Rattle –
Rear of Vehicle Underbody –
Repair Procedure

MODEL 1995-97 MY
Sedan Range
VIN 720001-812255

ILLUSTRATION 1

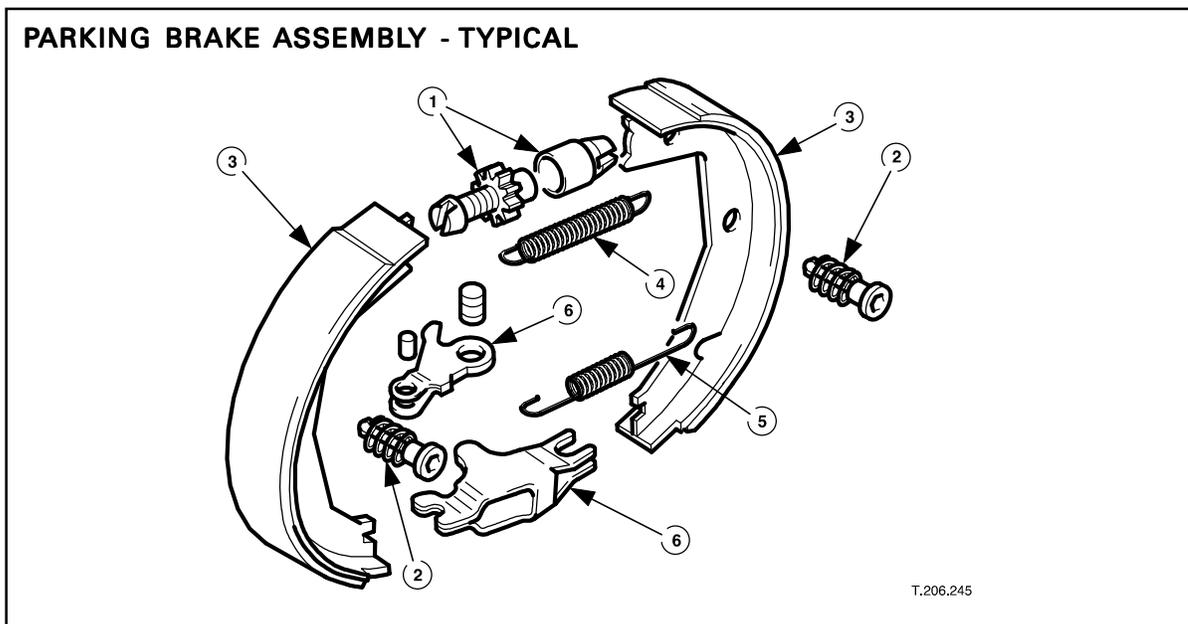
On 1995-97 MY Sedan Range vehicles, a rear-end underbody rattle may be caused by the parking brake mechanism.

Install rubber sleeves over each parking brake shoe lower return spring (Item 5, Illustration 1). The sleeves will exert pressure on the parking brake shoe spreader mechanism, to prevent it from rattling against the backing plate under certain conditions.

1. Raise and support the rear of the vehicle. Ensure that the parking brake is fully released.
2. Remove the rear wheels.
3. Disconnect the rear brake calipers, supporting them clear of the rear brake discs.
4. Without disturbing the adjustment of the parking brake shoes, remove the brake discs.
5. Release and remove the brake shoe lower return springs.
6. Slide a rubber sleeve over each spring. (See Parts Information).
7. Reinstall the springs, ensuring that the rubber sleeves are centered on each spring and that the sleeves exert a moderate pressure on the shoe spreader mechanism.
8. Reinstall the brake discs, pads, calipers and road wheels.
